**Brooks County High School and Junior High
Field House Plumbing Upgrades.**

ADDENDUM NO. 1

ADDENDUM NO. 1

DATE: July 02, 2025
Project: Falfurrias HS and JrH Fieldhouse Plumbing Upgrades
Project #: 25v51
To: David Monreal, GMS

EP4.01

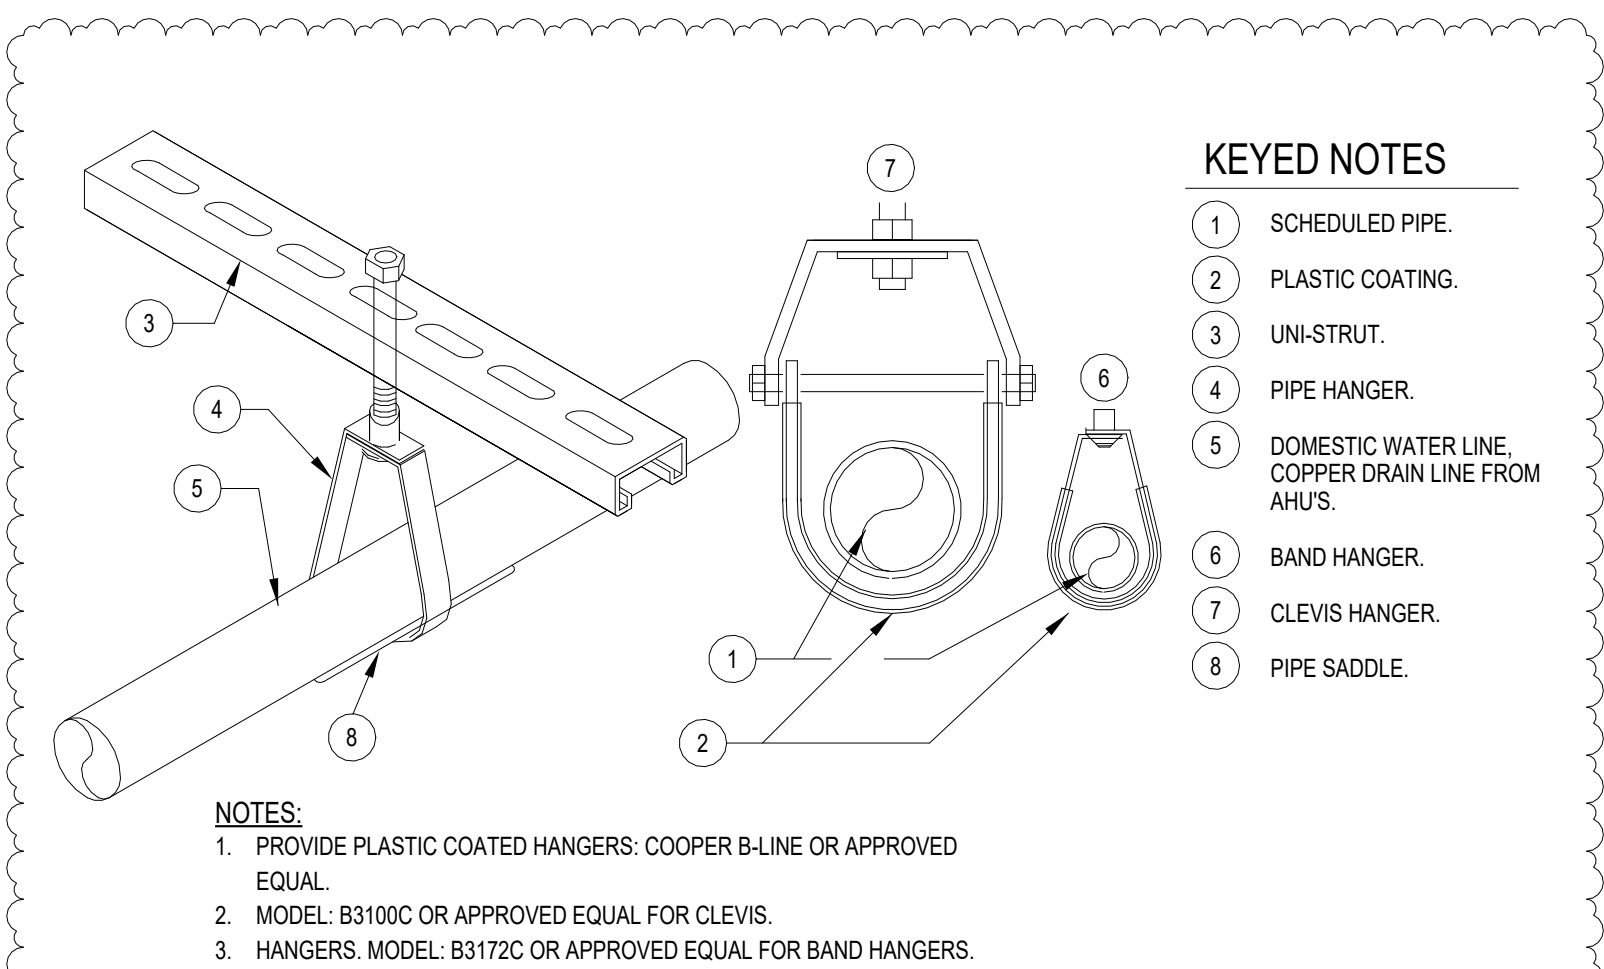
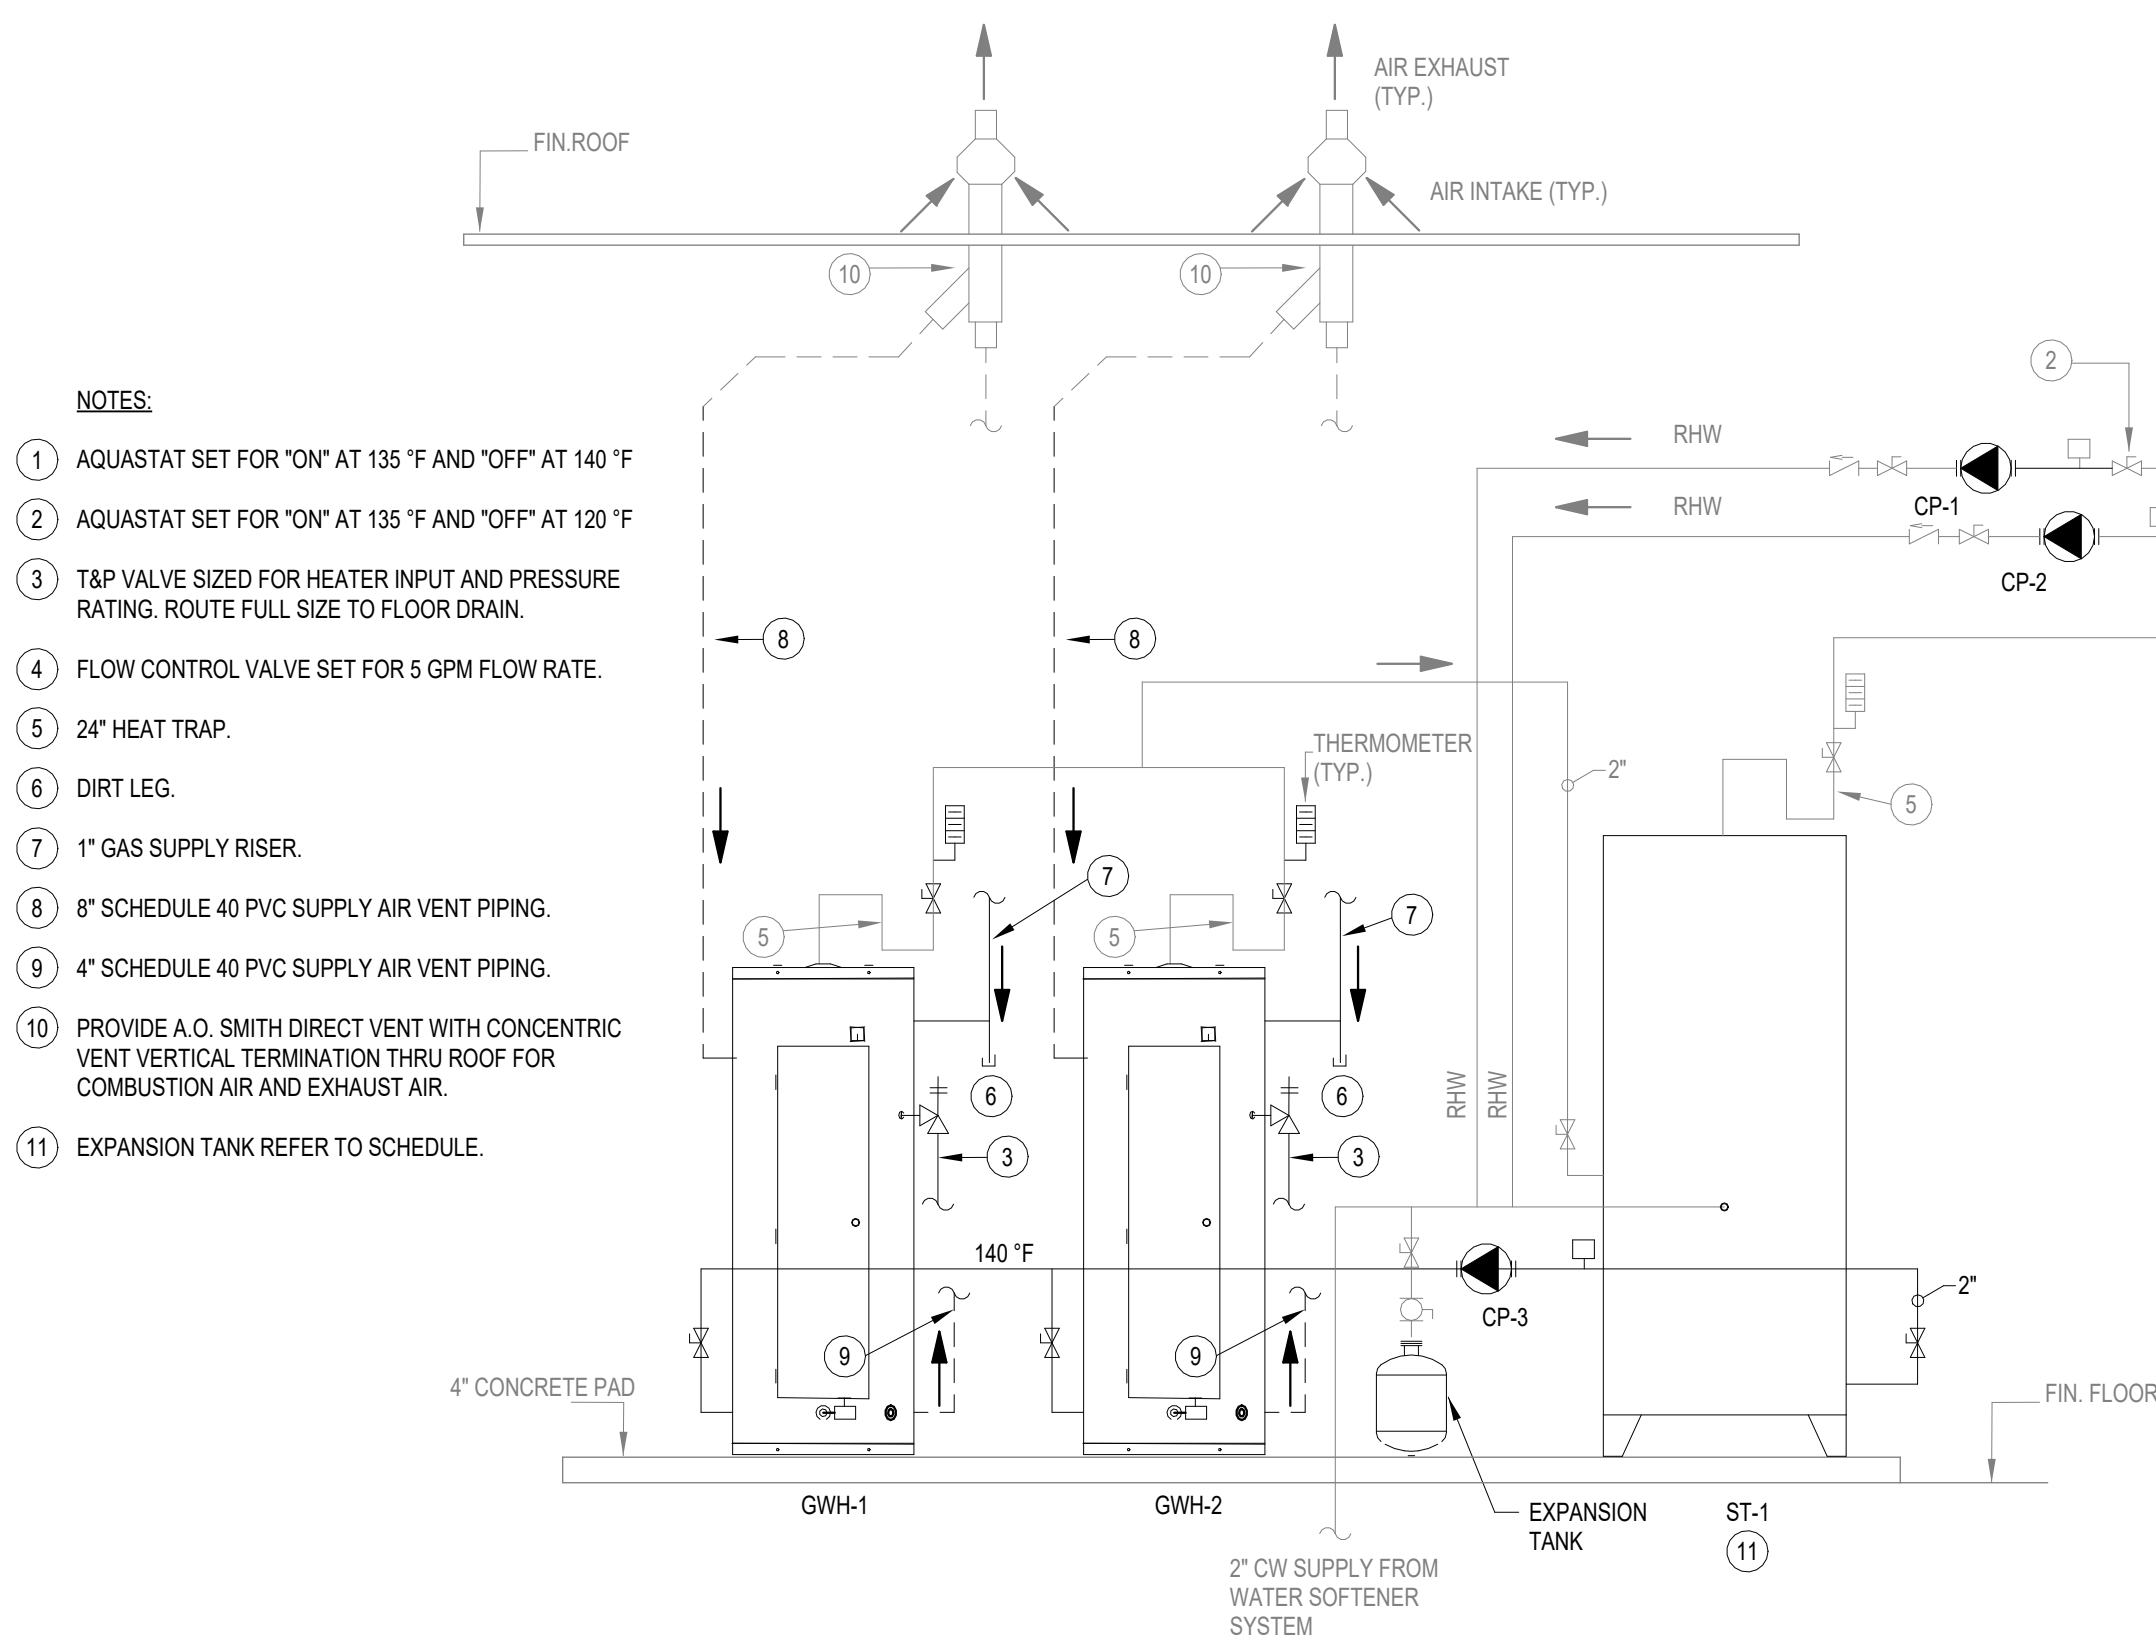
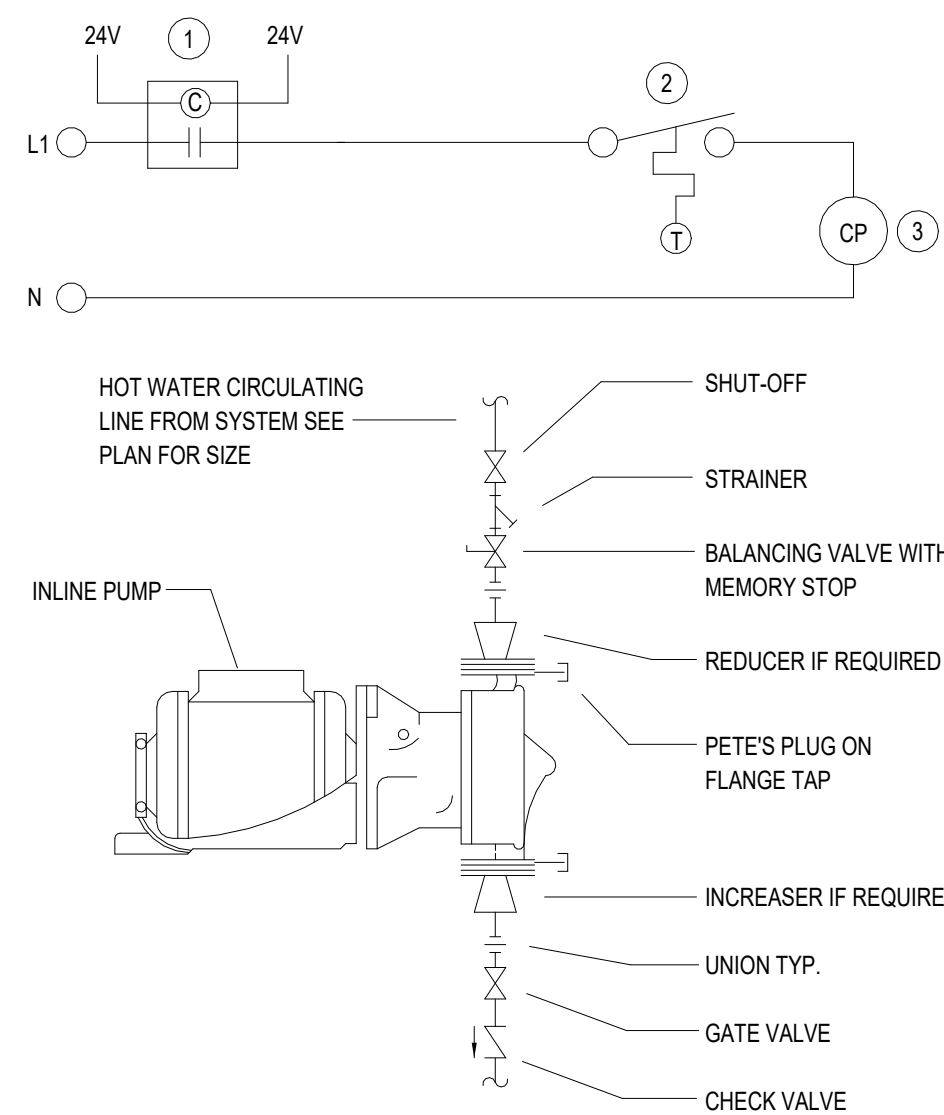
1. Sheet EP3.01:
 - a) Revised Electrical and Plumbing Renovation Plan. See attached sheet.
2. Sheet EP4.01:
 - a) Revised Electrical and Plumbing Schedules and Details. See attached sheet.
